To: T10 Technical Committee
From: Rob Elliott, HP (elliott@hp.com)
Date: 25 October 2002
Subject: 02-360r3 SAS spinup

Suggested Changes

Create a new ENABLE SPINUP primitive. Immediately after power on, it is used to trigger automatic spin-up; afterwards, it interacts with the START STOP UNIT command to delay when software-requested spin-up actually occurs.

Figure 1 — SCSI application layer power condition (SA_PC) state machine for SAS**0.0.1 SA_PC_0:Powered_On state****0.0.1.1 State description**

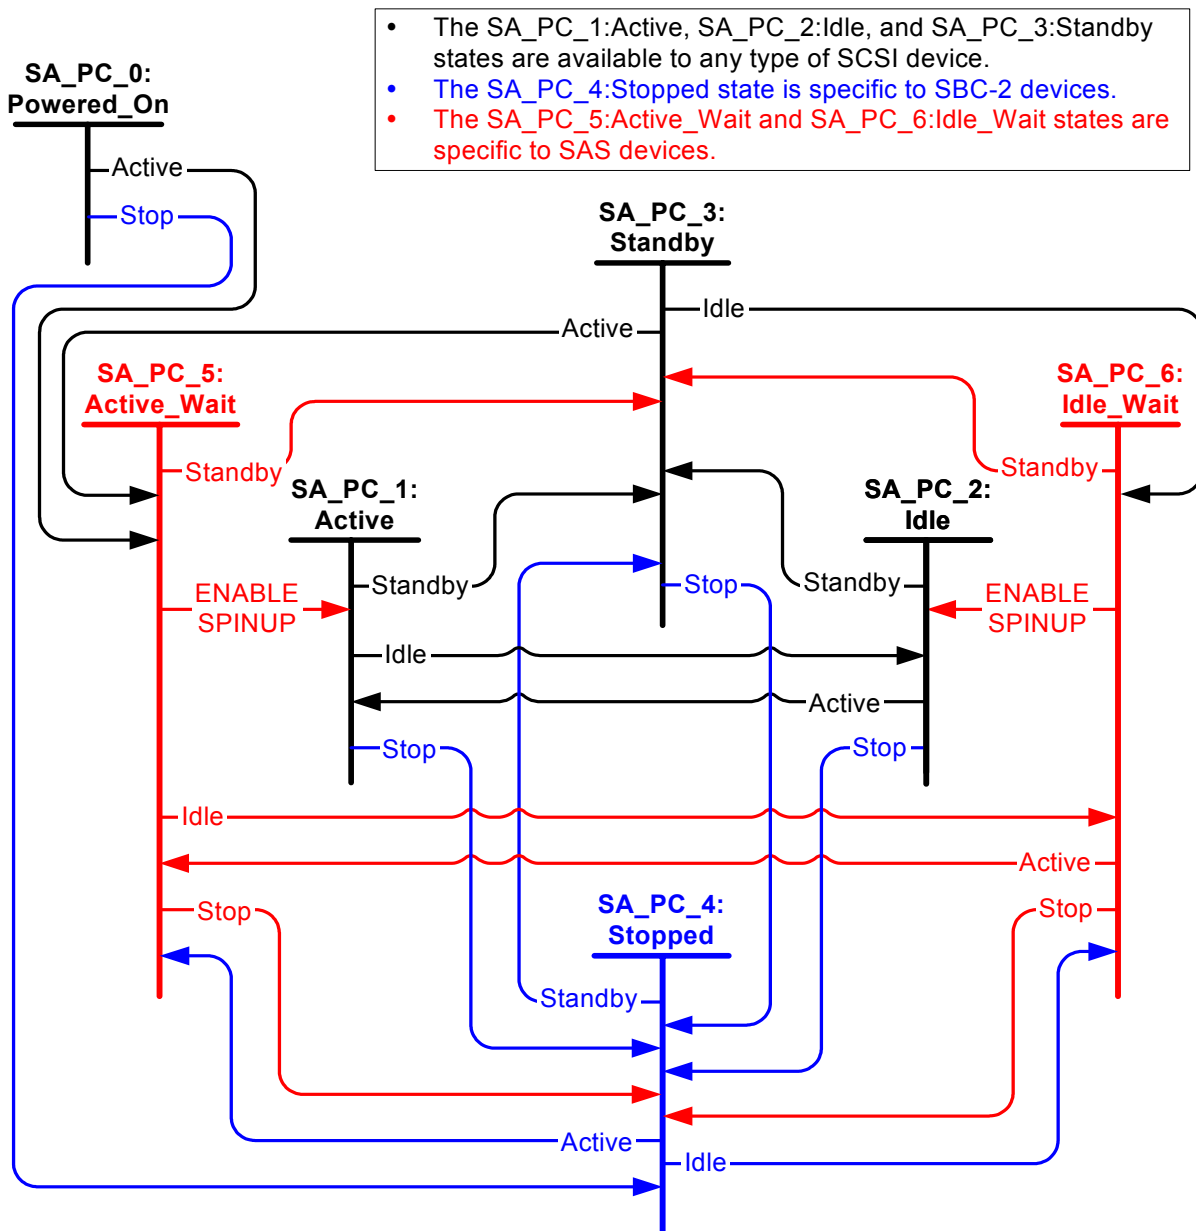
The SCSI application layer Power Condition (SA_PC) state machine describes how the target device processes logical unit power condition state change requests and ENABLE SPINUP. The SA_PC state machine is an enhanced version of the logical unit power condition state machines described in SPC-3, SBC-2, and RBC. The SA_PC states are as follows:

- a) SA_PC_0:Powered_On;
- b) SA_PC_1:Active;
- c) SA_PC_2:Idle;
- d) SA_PC_3:Standby;
- e) SA_PC_4:Stopped (specific to SBC-2 and RBC devices);
- f) SA_PC_5:Active_Wait (specific to SAS devices); and
- g) SA_PC_6:Idle_Wait (specific to SAS devices);

The SA_PC state machine stall start in the SA_PC_0:Powered_On state after power on.

Figure 1 describes the SA_PC state machine.
